UNITED STATES PATENT AND TRADEMARK OFFICE

10/624,542

Office Action Summary

DETAILED ACTION

FIG. 2

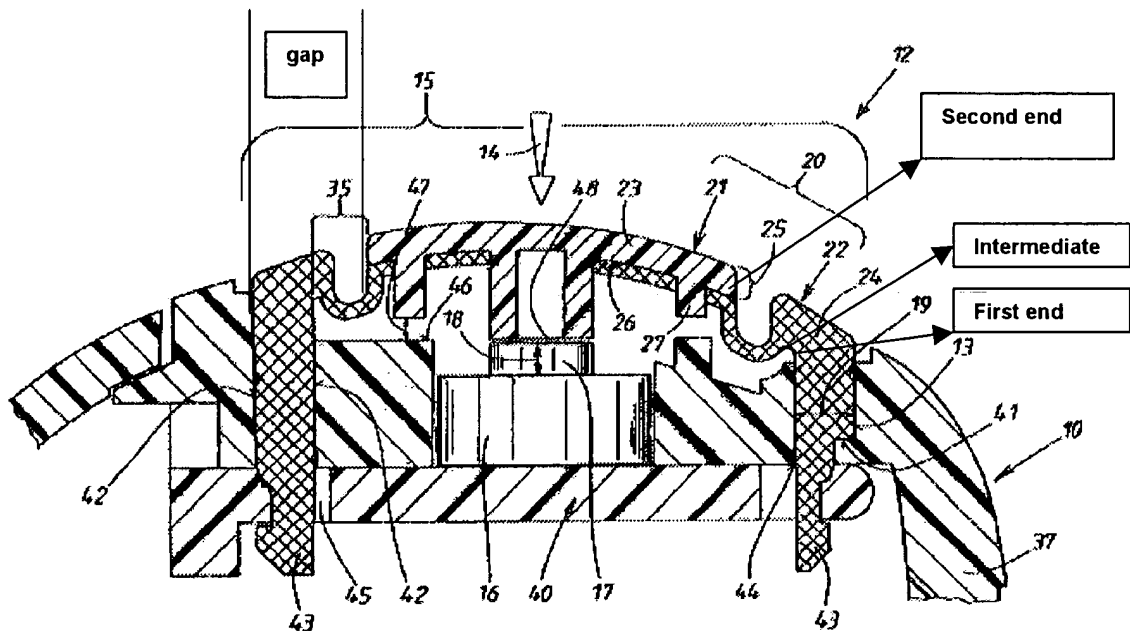
Klein discloses an electrical switch 16 contains moving and fixed contacts (not shown) comprising:

- a housing 10 having an opening 15;
- at least one moving contact movable by the switching member 17 for movement to come into contact with and out of contact from the fixed contacts (not shown), and
- an actuator cap 21 disposed in the opening for movement to actuate the switching member 17 and in turn the moving contact, with a gap (see the attachment) formed between the actuator cap 21 and the opening 15 that surrounds the actuator cap 21;
- wherein a resiliently deformable seal 22, 30 is connected across the opening 15 and the actuator cap 21 to seal off the gap (see the attachment), thereby avoiding entrance of foreign matter through the gap (see the attachment) into the housing 10;
- wherein the seal 22, 30 has a folded cross-section 29, 39 providing the extended length;

- the seal across section 29, 39 have a U-shaped bend pointing inwards;
- the seal 22, 30 has an intermediate portion (see the attachment) between the opening and the actuator, the portion being folded and having a reduced thickness;

- the seal 22, 30 comprises a sleeve 29, 39 having opposite ends connected to the opening (see the attachment) and the actuator cap 21 respectively, a first of the ends (see the attachment), being disposed around the corresponding one of the opening and actuator cap 21;

- the second end (see the attachment) is also disposed around the other of the opening and actuator cap 21;
- the first end is stretched around a part forming the opening or of the actuator cap 21 to which the first end is connected;

- the seal 34 comprises an inner part 29 and 39 that is resiliently deformable and an outer part 22 and 30 that is considerably thicker than the inner part 29 and 39 and surrounds and protects the actuator 21;

- the outer part 22 and 30 is *substantially* cylindrical and contains *substantially* wholly the inner part 29 and 39.
- the inner and outer parts together have a Z-folded cross-section;
